# AIA Document G701™ – 2017

## Change Order

**PROJECT:** (Name and address)  
Williamson County  
Animal Shelter Expansion  
1855 SE Inner Loop  
Georgetown, TX 78626

Change Order No. 3 includes the below listed Vaughn Change Proposals # 11-#17. For Vaughn Project No. 2491-01.

Sheet Content:  
**MAIN - DEMOLITION -  
 FLOOR PLAN**

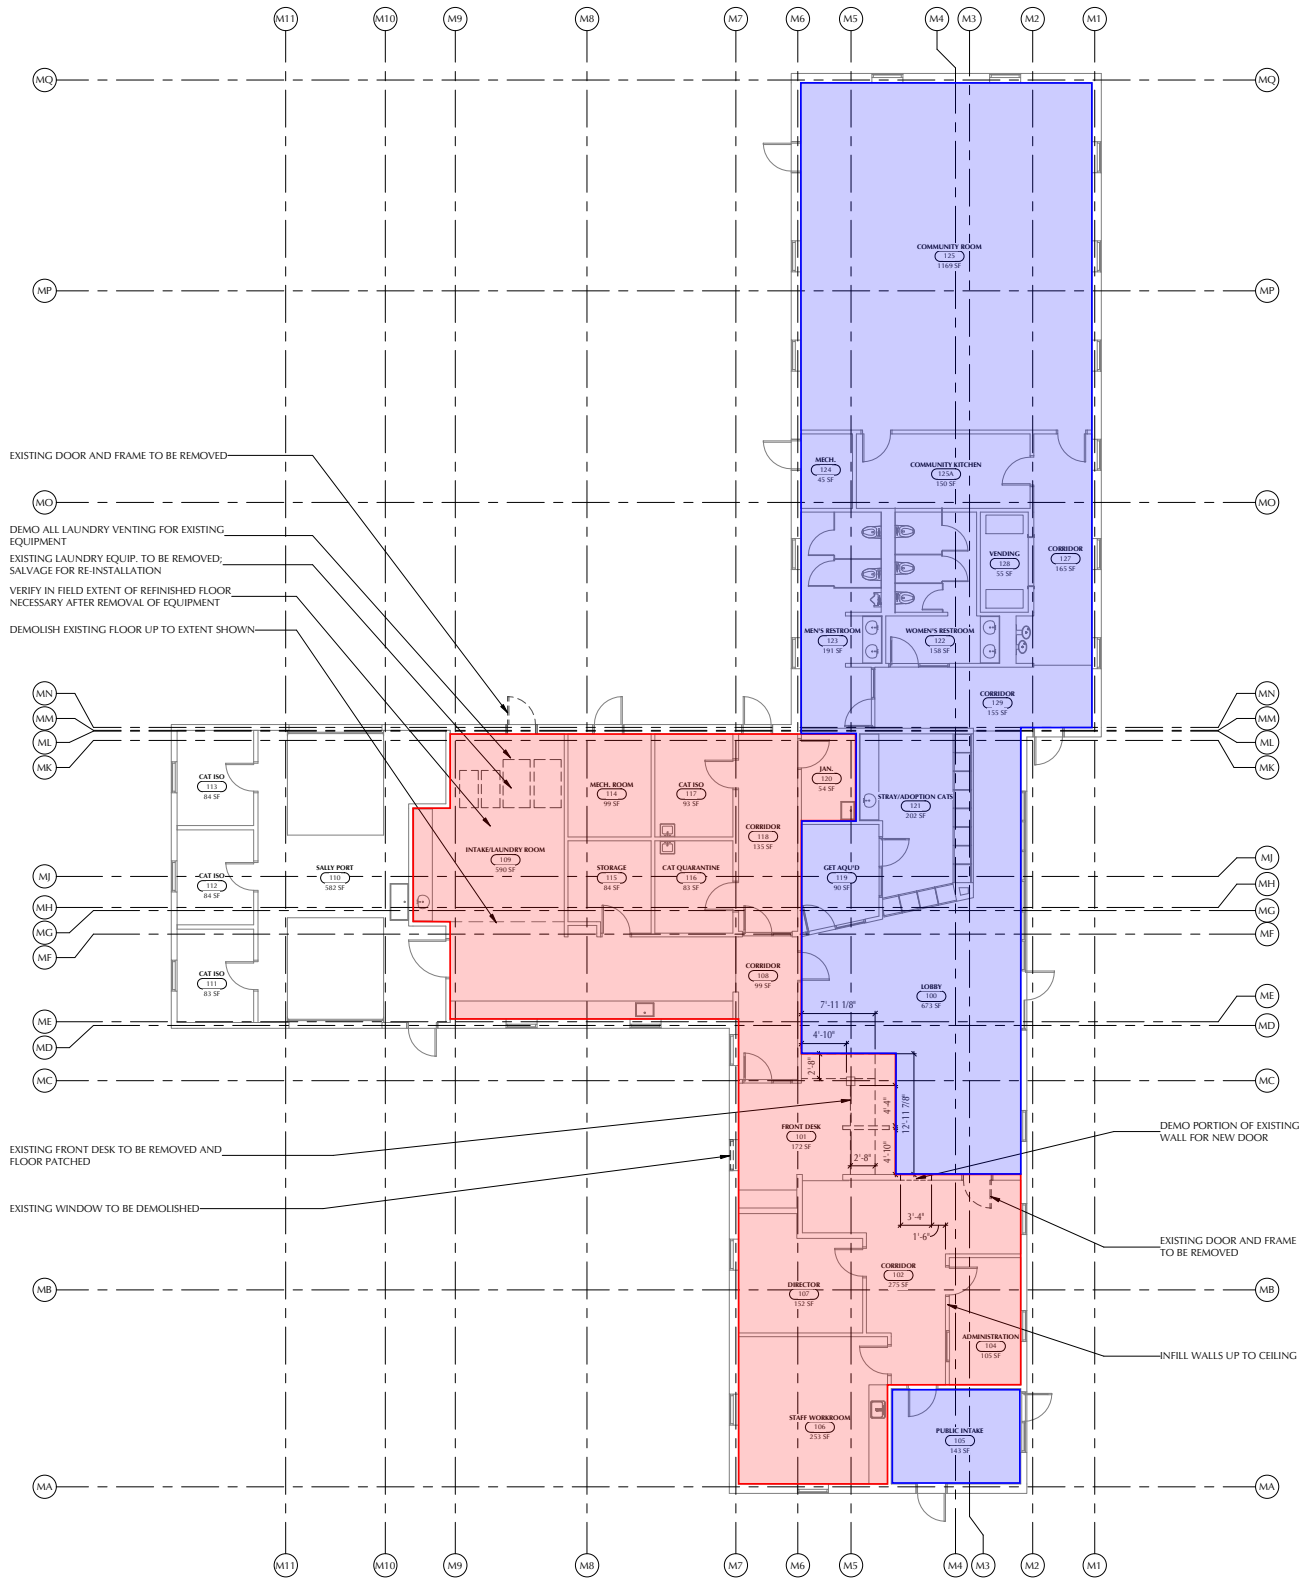
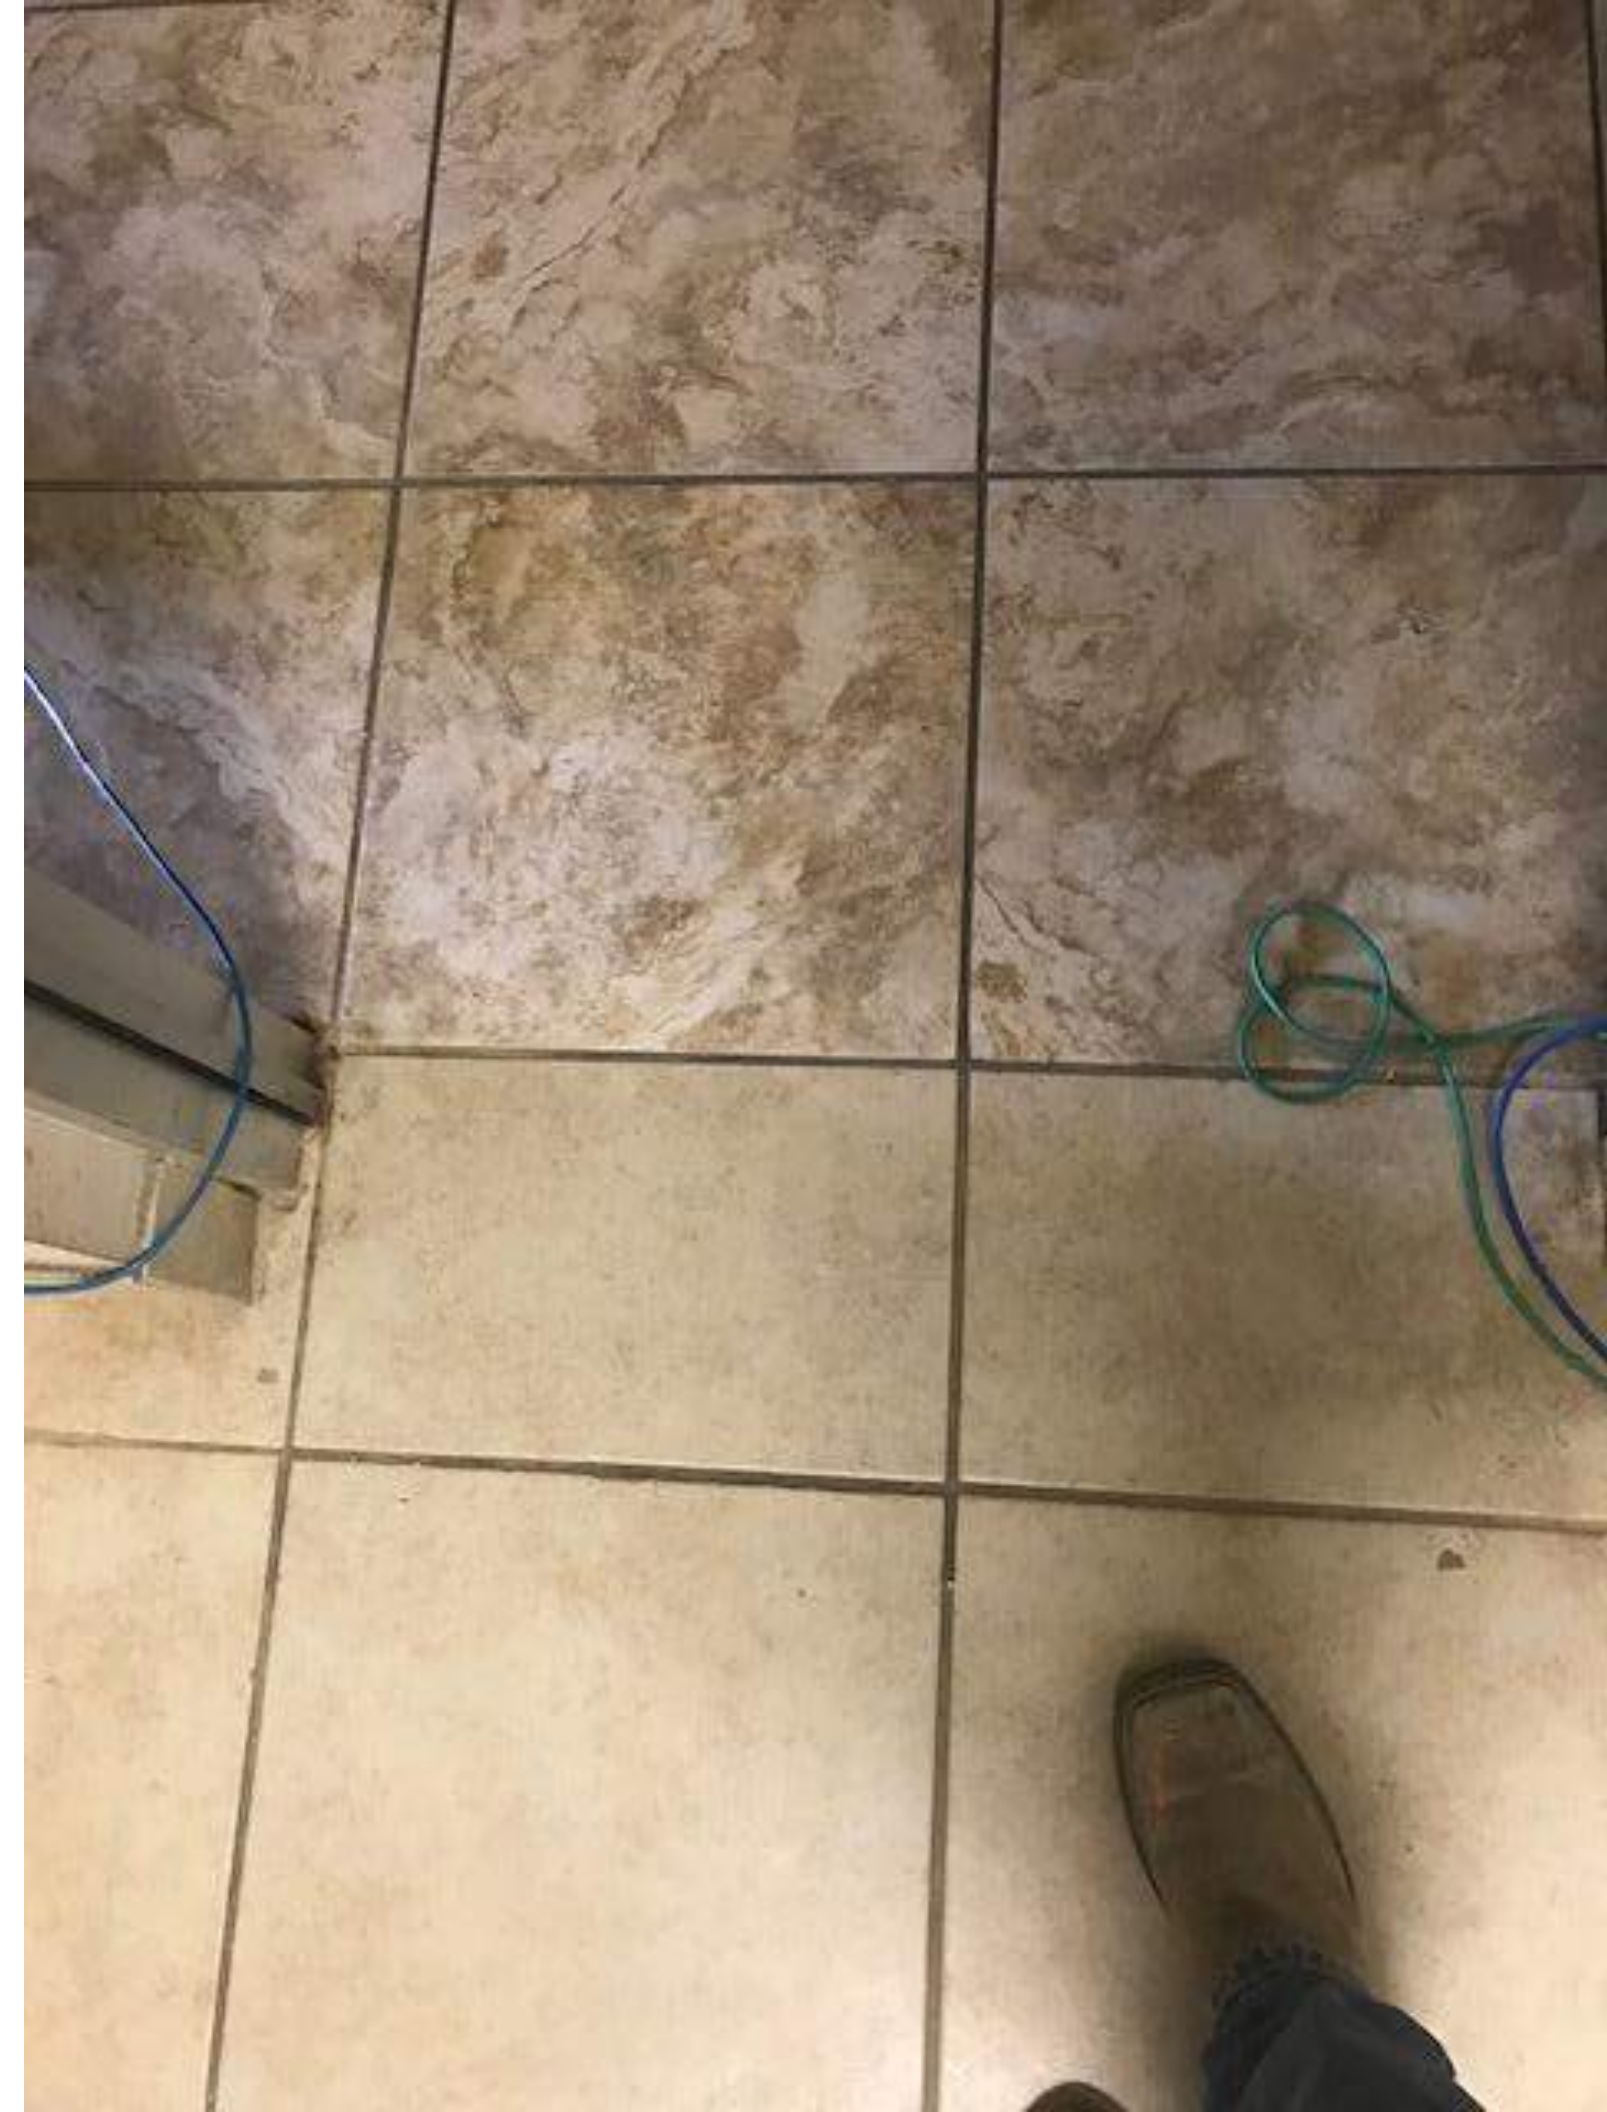
Sheet A.1-2.10 has a note to patch the tile flooring around the demolished existing lobby desk. This area has 2 different tile types (see attached) that are laid out in the middle of the lobby making patching and/of matching any tile very difficult as there will be a distinct transition on the visible lobby floor. Also, the county has confirmed that there is not attic stock of either tile.

WilCo found it acceptable to propose a defined area of further demolition of the existing floor tile and replace it with new floor tile, to match generally the size and pattern. Shelter Management requested the new tile be darker than the existing.

See revised Architectural sheet A.1-2.10, attached.
